Commission of Architectural Review

9. COA-166150-2025	Final Review	Meeting Date: 5/27/2025
Applicant/Petitioner	Adam Smith	
Project Description	Construct a new rear fence, chiminea, and replace windows.	
Project Location		
Address: 3422 East Broad Street, Richmond, VA 23223		
Historic District: Chimborazo Park		
<p>High-Level Details:</p> <p>The applicant proposes a series of rear-yard modifications, including the replacement of an existing fence, construction of a new deck connecting to an existing porch, rebuilding and screening of upper and lower porches, removal of faux brick siding with potential replacement using HardiePlank or preserved wood siding, installation of a freestanding brick fireplace, and replacement of existing windows with casement-style units.</p>		
Staff Recommendation	Approval, with Conditions	
Staff Contact	Yara Iwaz, Yara.Iwaz@RVA.gov, (804)646-6031	
Previous Reviews	<ul style="list-style-type: none"> • In June 2018, the Commission denied the application to install three vinyl casement windows in the rear was denied • In September 2018, the Commission approved the application to replace two wood windows with 1-over-1 double-hung windows and add a window o

Figure 1

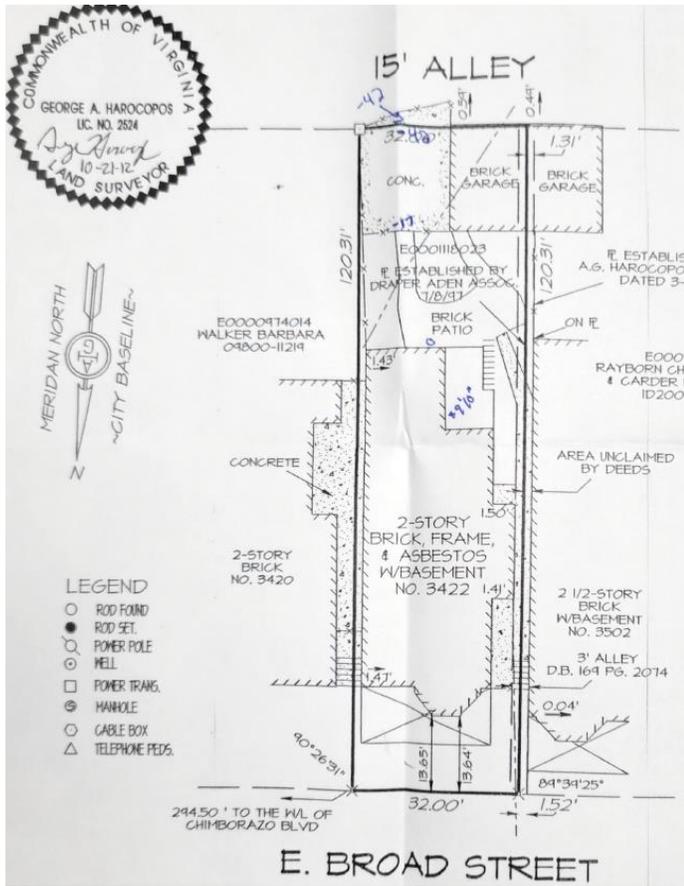
<p>Standards for New Construction, Materials & Colors, Page 53</p>	<p><i>2. Materials used in new construction should be visually compatible with original materials used throughout the surrounding neighborhood.</i></p>	<p>The proposed fence consists of a dark-colored metal frame with pressure-treated wood slats. While the fence is located at the rear and follows the footprint of the existing, the use of metal framing is not traditional and departs from the prevailing character of fences found in the district.</p> <p><u>Staff recommends using wood for both the frame and slats, to align with traditional materials and fence types. Staff also recommends submitting stain color for review to ensure compatibility with the historic context.</u></p>

<p>The new privacy fence is located in the rear yard, where the maximum height is determined by zoning regulations.</p> <p><u>Staff recommends confirming maximum allowable height for the privacy fence and abiding by all zoning regulations.</u></p>
Standards for New Construction, Materials & Colors, Page 53	<i>2. Materials used in new construction should be visually compatible with original materials used throughout the surrounding neighborhood.</i>	<p>The proposed fireplace chimney is to be constructed of brick and painted.</p> <p><u>Staff encourages the use of brick which will be in keeping with the surrounding context of the alley and the district and recommends submitting final colors for approval. Referencing alley-adjacent materials and forms in the district can further support material compatibility decisions, particularly for the chimney and fencing.</u></p> <p><u>Additionally, staff recommends avoiding paint that can trap moisture in masonry.</u></p>

Figure 2

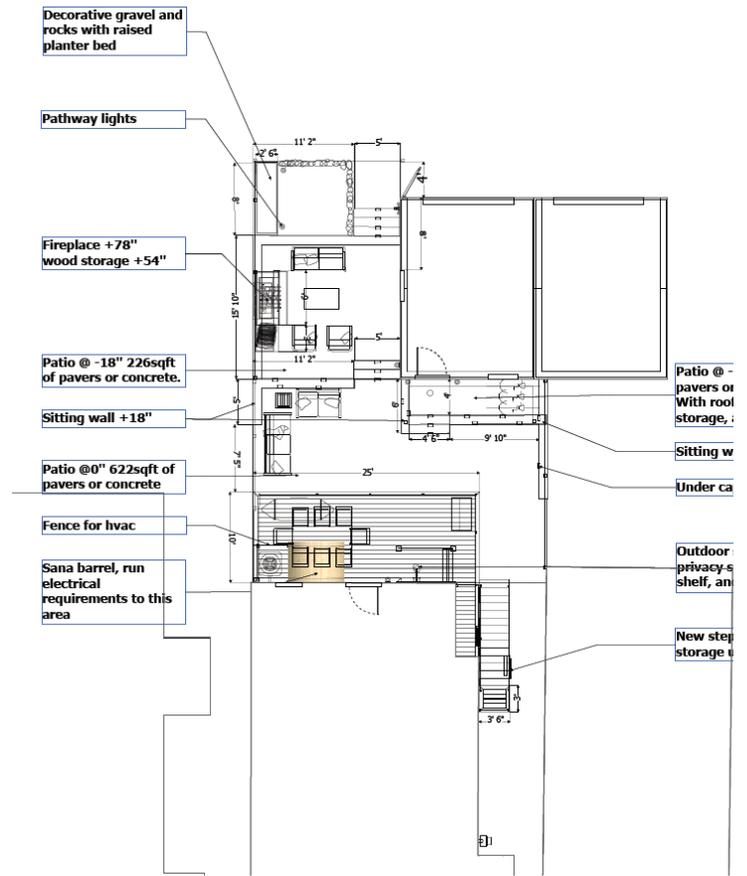
Substitute Materials, 3. Replacement of Poor Quality Materials, pg. 61	<i>The problems associated with the use of poor quality original materials can be remedied by in-kind replacement. If in-kind materials cannot be found, or are impractical, substitute materials can be used.</i>	<p>The applicant proposes removing existing faux brick siding and either preserving/replacing original wood siding or using Hardiplank as a substitute.</p> <p><u>Staff encourages the preservation and repair of original wood siding. If replacement is necessary, staff recommends that Hardiplank should match the appearance and texture of the original siding.</u></p>
Building Elements, Windows, pg. 69	<i>The architectural character of windows should not be altered by inappropriate materials or finishes that radically change the sash, depth of reveal, muntin configuration, the reflective quality or color of the glazing or the appearance of the frame.</i>	<p>The proposed casement windows (48" x 72") are located at the rear but are visible from the public right-of-way. Casement windows do not match the traditional double-hung style prevalent in the district.</p> <p><u>Staff recommends denying the use of casement windows and recommends replacement with double-hung windows that match the original in size, configuration, and operation. If operational concerns exist, consider alternative solutions that maintain the historic appearance. If the concerns relate to the energy efficiency of existing windows, staff recommends treatments such as routine maintenance, weather-stripping, and the installation of storm windows.</u></p>
